EA Engineering, Science, and Technology, Inc.

RE: Response to Comments from the Rhode Island Department of Environmental Management,  
Dated 19 August 2004, on the Remedial Action Work Plan for the Lincoln Luce  
and Braid Former Ponagansett Dump, 67 Melissa Street, Providence, Rhode Island  
Case No. 2001-024  
EA Project No. 61846.01

**Revised Remediation Schedule  
with Milestones for Construction Activities**

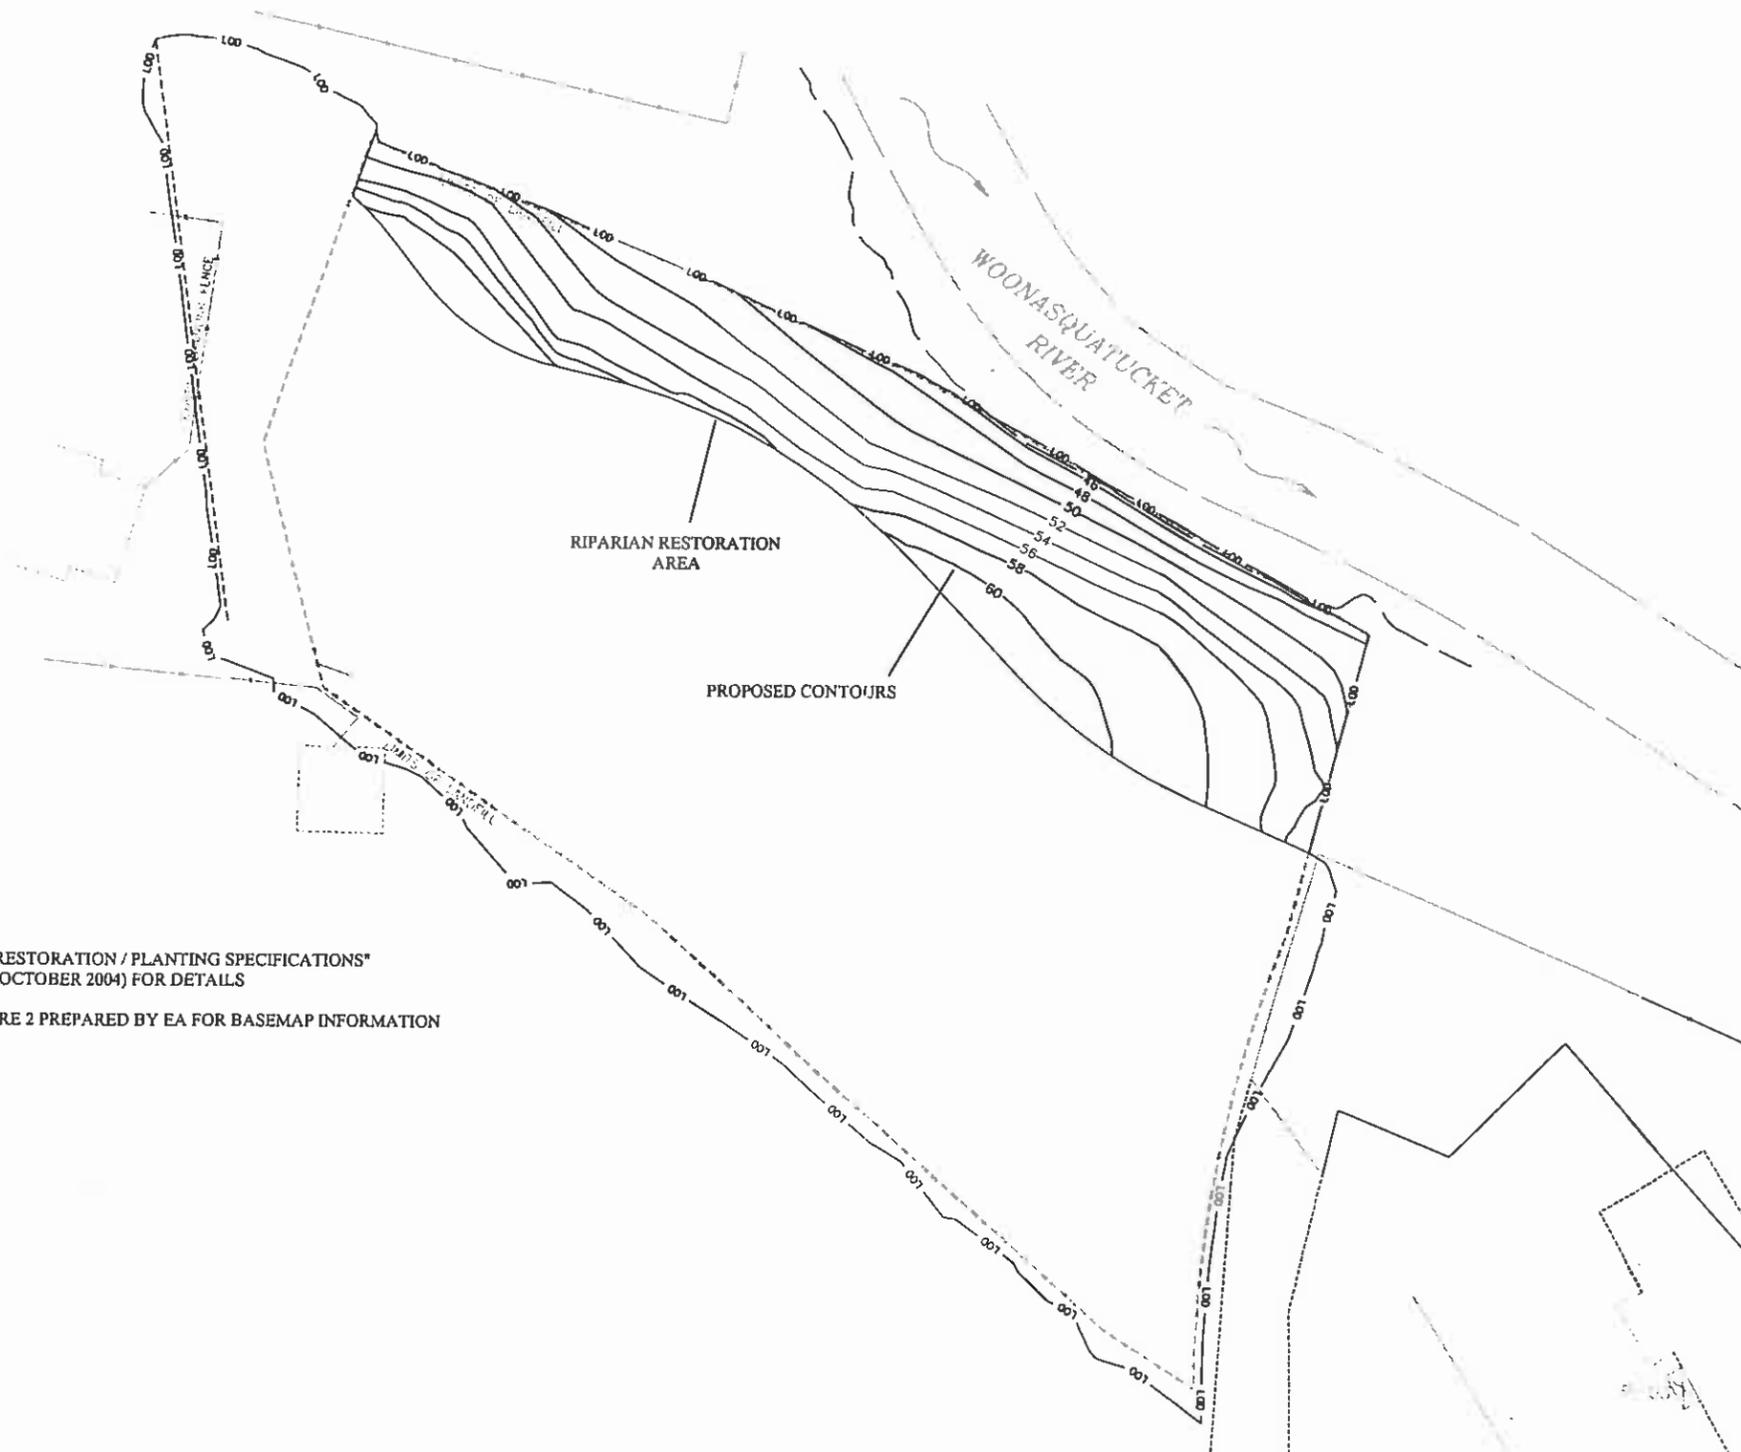
- 8. Please provide a more detailed remediation schedule addressing the sequencing and duration of the main elements of the proposed Remedial Action. This would include, but may not be limited to, debris and surficial solid waste removal, establishment of erosion controls, clearing and grubbing, regrading, cap construction, buffer restoration, seeding, and post-remediation site inspections and reseeded as necessary to ensure the establishment of adequate and uniform vegetative cover.**

Attachment D includes a revised remediation schedule with milestones for construction activities. The general contractor will prepare a detailed schedule in Spring 2005. This schedule will include actual milestone dates.

FIGURE 2  
 EXISTING CONDITIONS PLAN

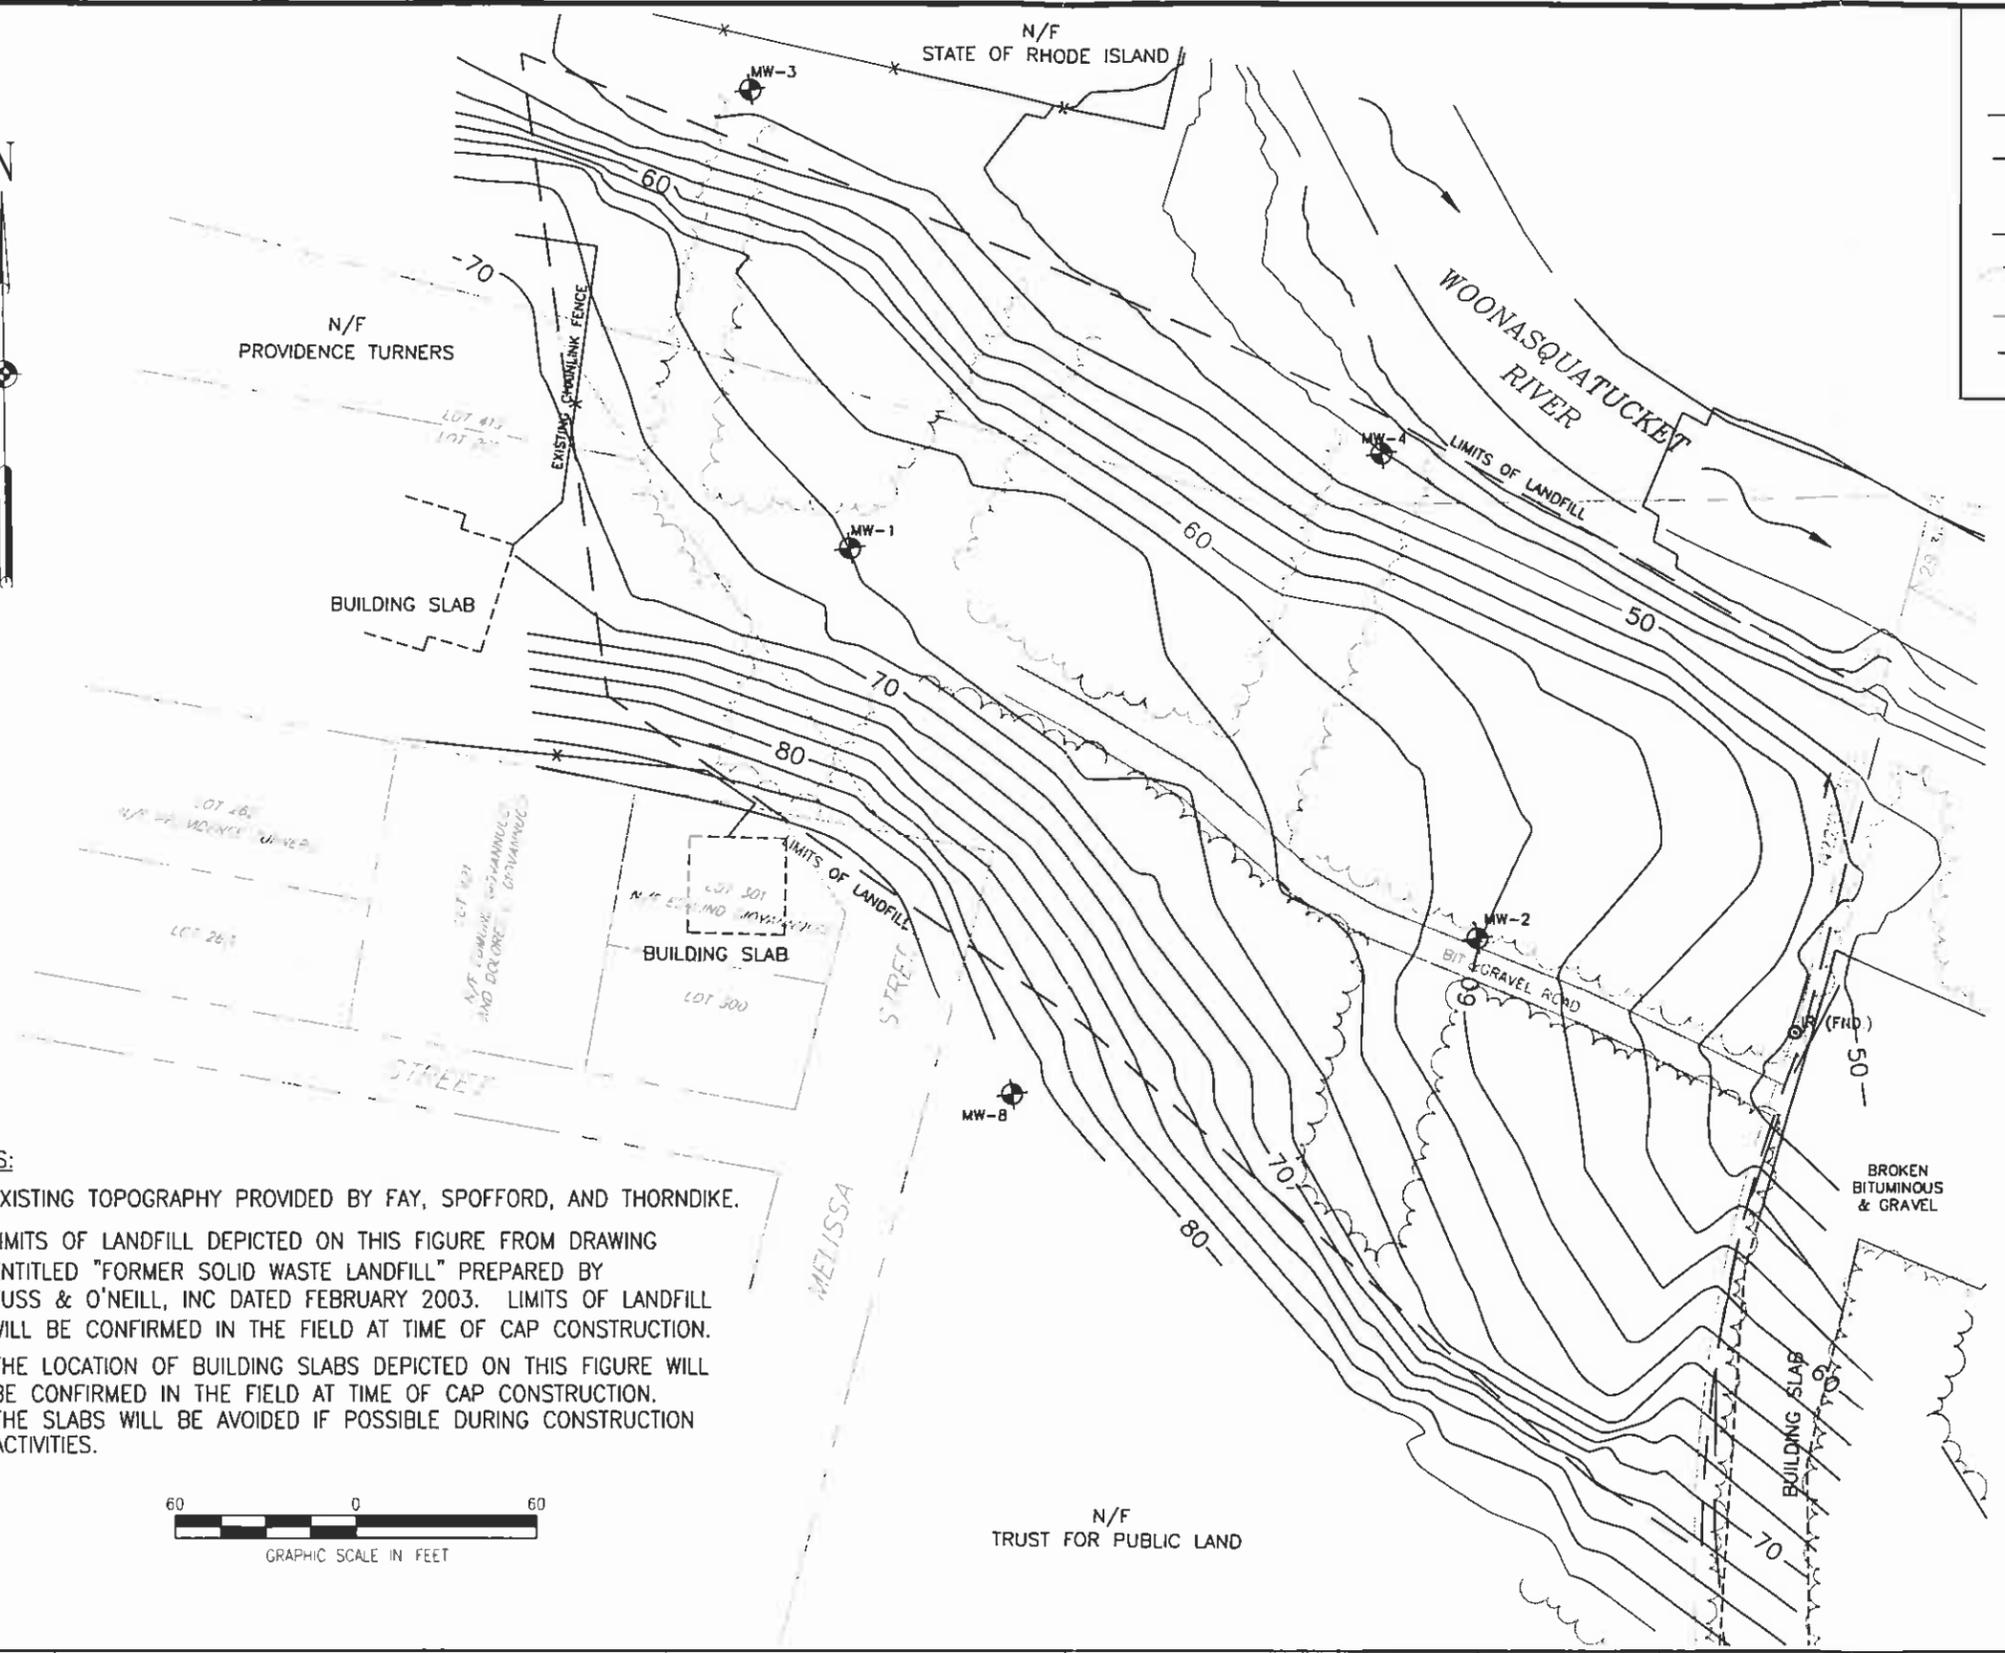
14. **Please provide a revised site plan that depicts the following:**

- a. **The location of the 100-year floodplain associated with the Woonasquatucket River. The narrative states that most of the restoration activity is planned within the 100-year floodplain.**
- b. **All existing and proposed grades within the 100-year floodplain.**
- c. **The limits of the proposed riparian restoration area. These are not clearly depicted on the plans provided.**
- d. **All proposed grades within the riparian restoration area. Proposed grades illustrated on the provided plans cannot be determined. If necessary, please provide a larger scale drawing of this area.**
- e. **The proposed locations for all materials to be stockpiled.**
- f. **The locations of proposed dewatering areas, if any, along with a details of the proposed dewatering basins.**

Revised Figures 2 through 5 are included in Attachment E. The revised figures include the information requested above. Because handling of saturated soil is not expected, no proposed dewatering areas nor related details have been included in the revised figures. All construction material stockpiles will be located within the limits of construction. As a clarification, please note that the narrative incorrectly stated that most of the restoration activity would occur within the 100-year floodplain. In fact, none of the restoration area lies within the floodplain. The page of the RAWP associated with this clarification has been revised and is included as Attachment B.

TYPICAL CAP SECTION DETAIL (3) (4/4)

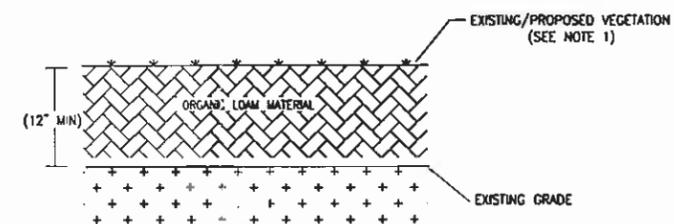
- 4. The design details in the RAWP depict a different engineered barrier than the one discussed in the RAWP narrative. Similarly, the engineered barrier discussed in the Soil Management Plan is also inconsistent with the other design proposed in the RAWP. Please revise these accordingly.**

The engineered barrier proposed for the site consists of a geotextile fabric covered with a minimum of 8 in. of gravel and 4 in. of organic soil as described in the Soil Management Plan and shown on the drawings. The page of the RAWP associated with this clarification has been revised to indicate the design proposed on the drawings and in the Soil Management Plan. This revised page is included as Attachment B.

TYPICAL RIPARIAN RESTORATION CAP DETAIL (4) (4/4)

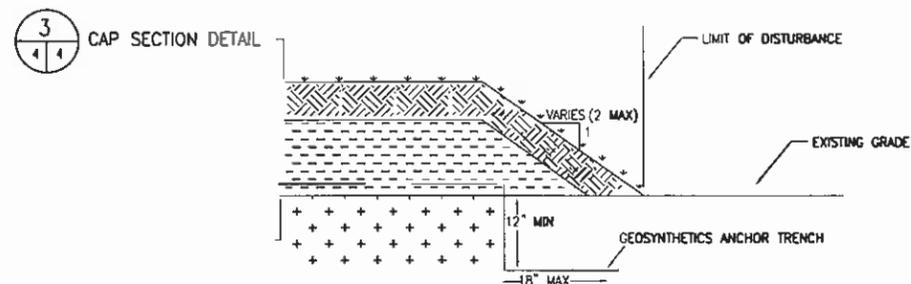
- 5. The engineered barrier proposed in the RAWP for the riparian buffer area consists of only 12 inches of topsoil. The engineered barrier proposal does not meet the Department's standard design requirements for two (2) feet of clean fill or equivalent. Please revise the proposed engineered barrier design for this area to one consistent with Department requirements.**

The 12-in. thick soil barrier was selected for the riparian buffer area because it is anticipated that removal/regrading of discrete waste (e.g., surficial debris and soil piles) and placement of the proposed cover soil and riparian buffer plantings detailed in Attachment A will not result in a net decrease in flood storage capacity. In order to eliminate flood storage reduction and install the requested 2-ft thick cap, the area would have to be cut by an additional foot prior to installation of the 2-ft cap. This additional cut would require removal of substantial vegetation along the riparian zone and riverbank. It is important to maintain the existing vegetation for a number of reasons:

- The foliage acts to slow floodwaters on or near the bank and minimize erosion of landfilled materials.
- Plant root structure acts as a soil binder that further protects the bank from erosion or slope failure.
- Plant structure removes water from the soil through transpiration reducing hydrostatic forces that could cause failure of certain soils.
- The foliage provides a stable location for establishment of volunteer and planned plant growth that further stabilizes the area and provides a natural appearance.
- Canopy from larger trees reduces impact of solar radiation on the water surface, maintains cooler airflow over the stream, and is more conducive to survival of coldwater fish species.

It is important to note that installation of a geotextile and a 1-ft thick cap in this area will result in similar loss of vegetation.

EA recommends maintenance of the vegetative cover in the riparian zone to the extent practicable to minimize erosion and slope failure, and our design reflects this recommendation.

TYPICAL CAP TERMINATION DETAIL (5) (4/4)

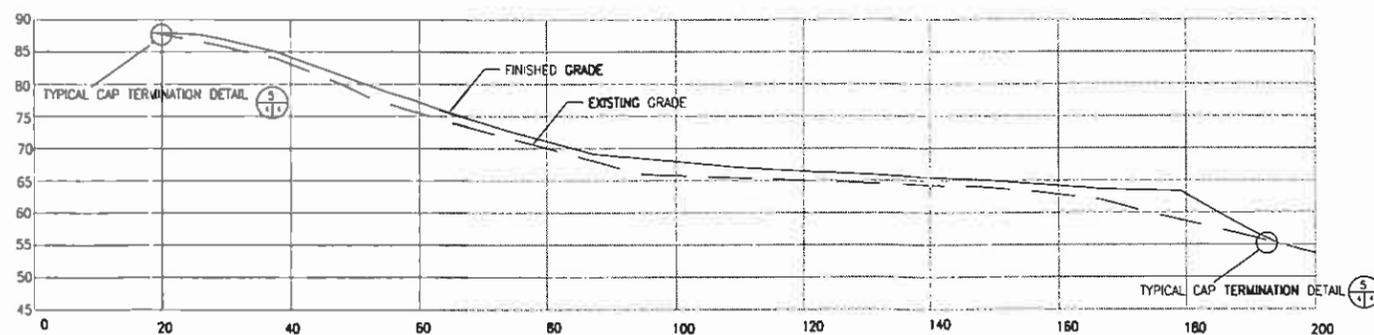
15. **Please explain the “proposed grade break” line depicted on the “Proposed Redevelopment Plan.” It appears that grading is proposed outside of the line.**

In general, a grade break line indicates the point where a design slope transitions from one consistent grade (e.g., 20 percent) to another (e.g., 5 percent). In this case, the proposed grade break depicted on the Proposed Redevelopment Plan (Figure 5) indicates the point at which the final grade in the cap area tapers to meet the existing grade, as shown on the Typical Cap

Termination Detail (Detail 5 on Figure 4). Grading is proposed outside the line because the proposed grade continues beyond the grade break until it intersects the existing grade.
